**MEMORANDUM**

**SUBJECT:** Design Standard (DST) 97-1, Jetway Systems Service Bulletin #091

**JETWAY SYSTEMS®**  
**SERVICE BULLETIN NUMBER 91**

**Rotunda Rigid Frame Weld Inspection for 18" Diameter Rotunda Columns**

Figure 1. Rotunda Rigid Frame Weld Inspection

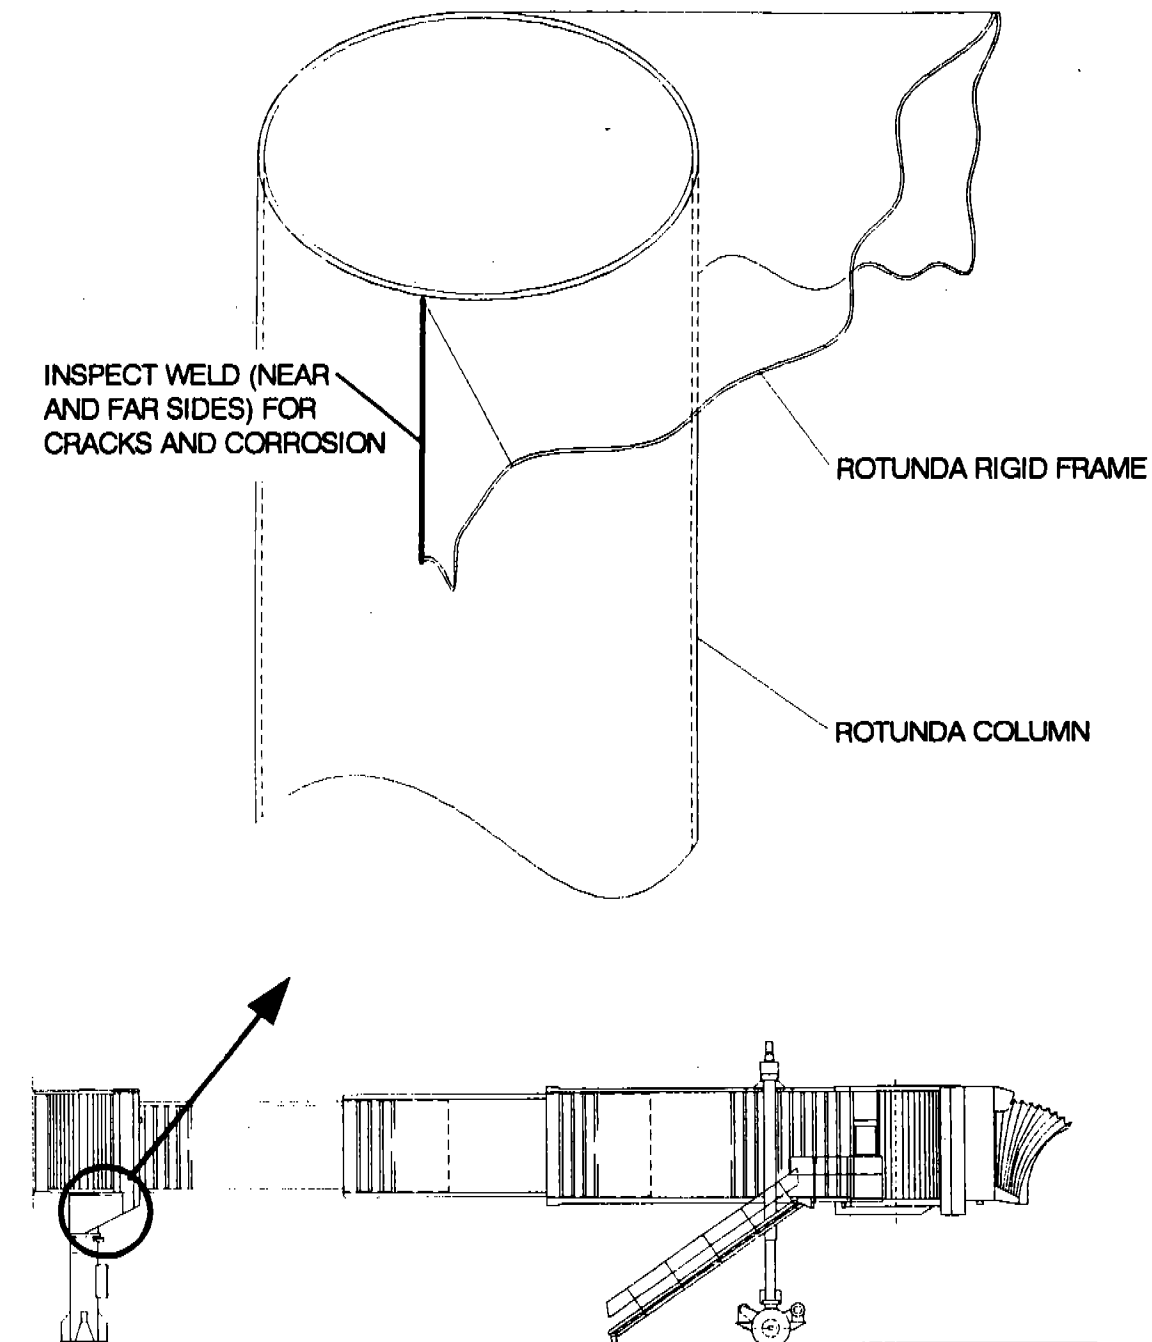
The inspection procedure outlined below should be performed immediately and then quarterly in conjunction with the normal preventive maintenance performed on the bridge. See Figure 1.

Refer to Figure 1. Visual inspection can be used to determine the presence of cracks. First, clean all areas to be inspected. Examine the entire weld surface, the interface between the weld bead and the plate and the interface between the weld bead and the pipe (use a lamp if required). Look for signs of cracking in or around the weld. Acceptable welds shall be free of cracks, rust and corrosion.

Figure 2. Reinforcement Plate.

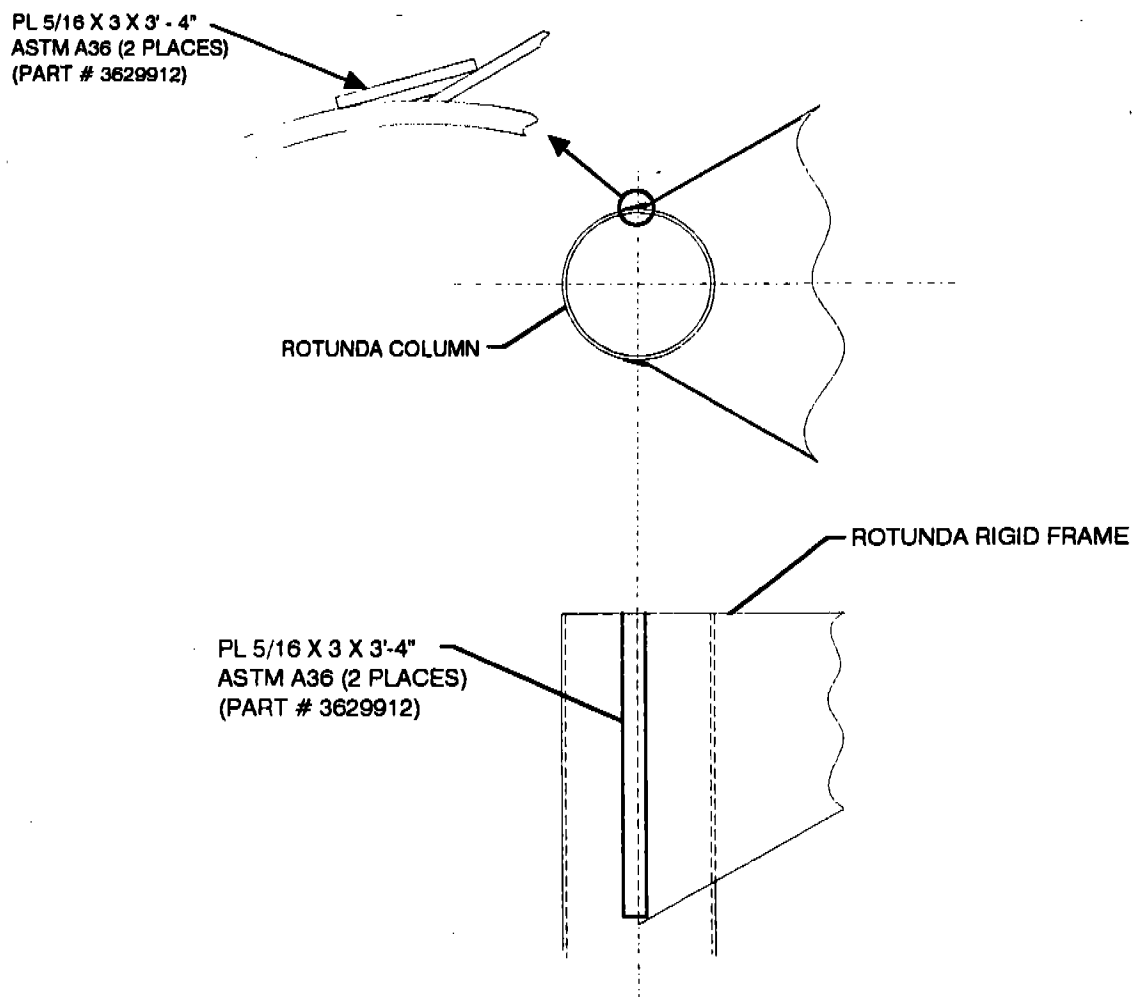
The plates will be sent from Jetway Systems at no cost, or they can be made locally using the parameters in Figure 2.

Report your findings to Jetway Systems, using the attached fax sheets. Provide a response for each PBB serial number at your location, **18" diameter rotunda columns only**. Make additional copies of the second page of the fax form as required. Upon receipt, Jetway Systems will supply two (2) plates, part number #3629912 (PL 5/16 x 3 x 3'-4), for each PBB requiring weld repair.

**Figure 3: Joint Details.**

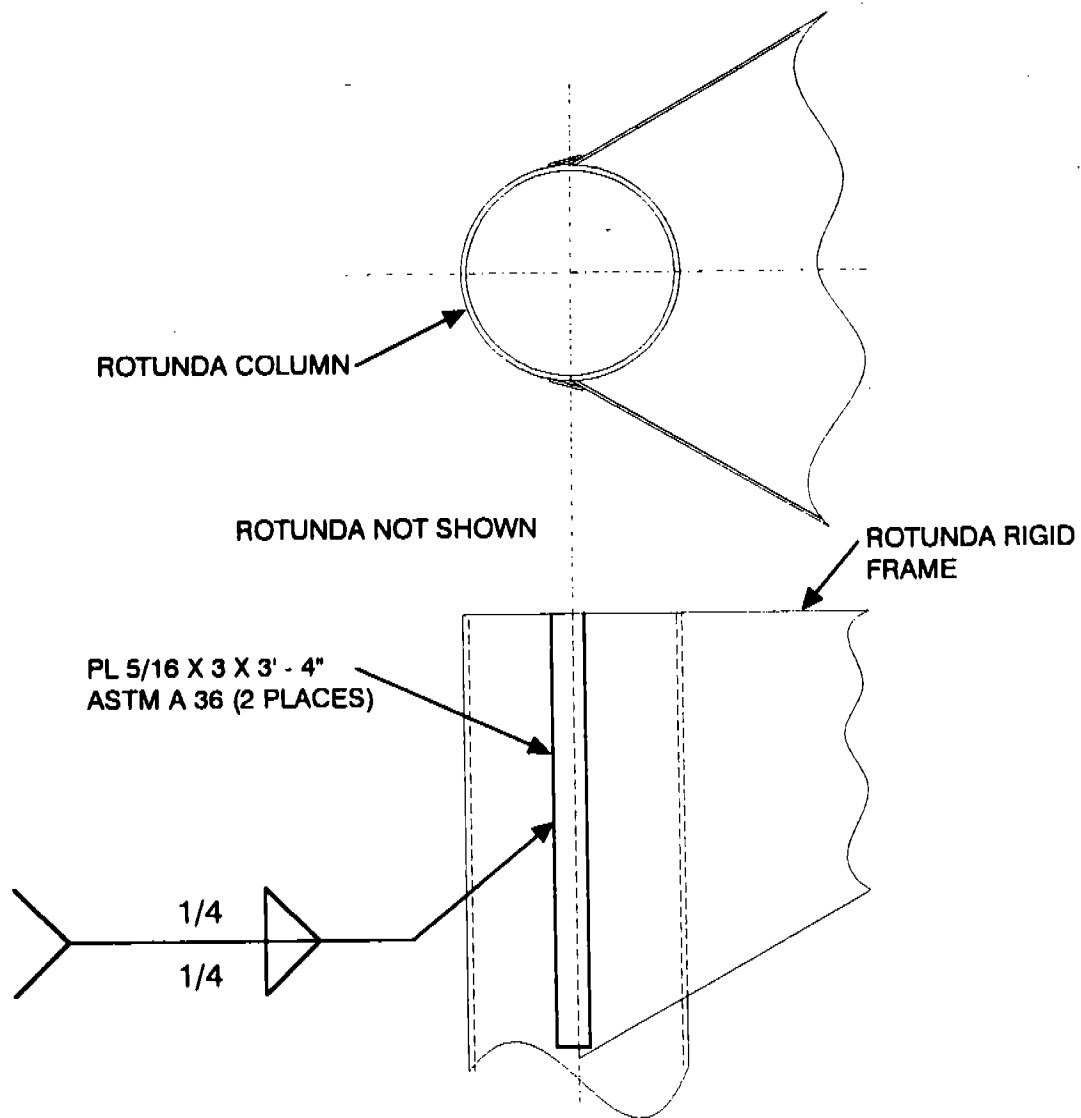
Position the PBB at a convenient location. Support the PBB with cribbing or a maintenance frame placed under tunnel C, approximately 6 feet in front of the vertical drive columns. The cribbing/maintenance frame should be placed under the tunnel C I-beams. Turn off the power at the rotunda disconnect. Review Service Bulletin No. 72 (attached) prior to welding on the PBB. Follow the instructions in the attached welding procedure. Locate the plates as shown in figure 3. After welding the plates, the welded areas need to be primed and repainted.

**Joint Details:** See Figure 3.
